APPLICATION NO.	FILING DATE	FIRST NAMED INVENTOR	ATTORNEY DOCKET NO.	CONFIRMATION NO.
10/743,854	12/22/2003	Kunitake Matsushita	31647-5	9104

Office Action Summary

DETAILED ACTION

FIG. 1

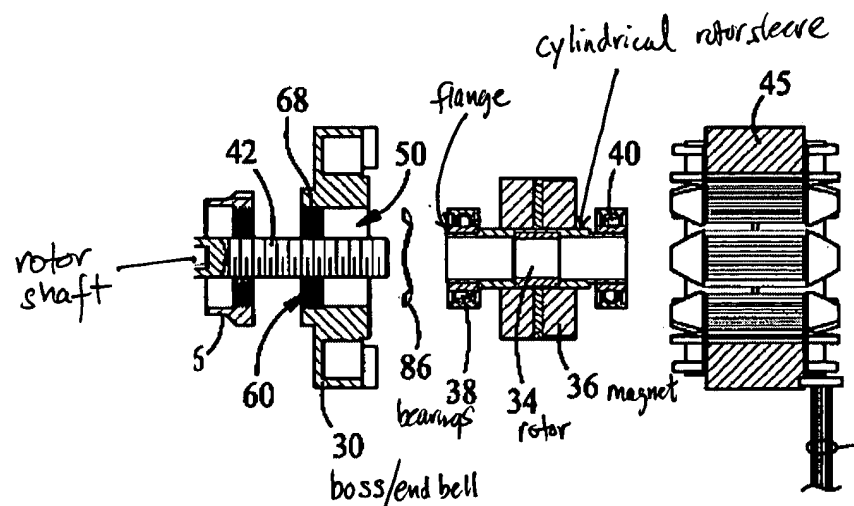
6. Claims 1, 6 and 8 are rejected under 35 U.S.C. 102(e) as being anticipated by Toye (US 6,603,229). Toye teaches a motor comprising: a rotor 34 including a shaft (not numbered; Fig.1) and a magnet 36 surrounding a portion of the shaft; a stator 45 surrounding the magnet of the rotor with a gap therebetween (not numbered, Fig.2), and adapted to generate a magnetic field thereby causing the rotor to rotate around an axis of the shaft (inherent); a rotor sleeve having a cylindrical portion (not numbered, Fig.1) and a flange (not numbered, Fig.1) provided at one end of the cylindrical portion, the rotor sleeve being provided between the magnet and the shaft so as to fixedly hold the magnet and the shaft together (Fig.2); a boss (end bell) 30 having a circular shape with a center hole 50 for allowing the shaft to rotatably pass therethrough (Fig.1), and being fixedly attached to the stator 45 so as to oppose the flange of the rotor sleeve (Fig.2); and a plurality of bearing balls 38 rotatably disposed between the boss and flange of the rotor sleeve (Fig.2).

Regarding claim 6, note sleeve bearing 80 (Figs.1&2).

Regarding claim 8, one exposed end 42 of the shaft comprises a threaded, spiral portion (Fig.2).
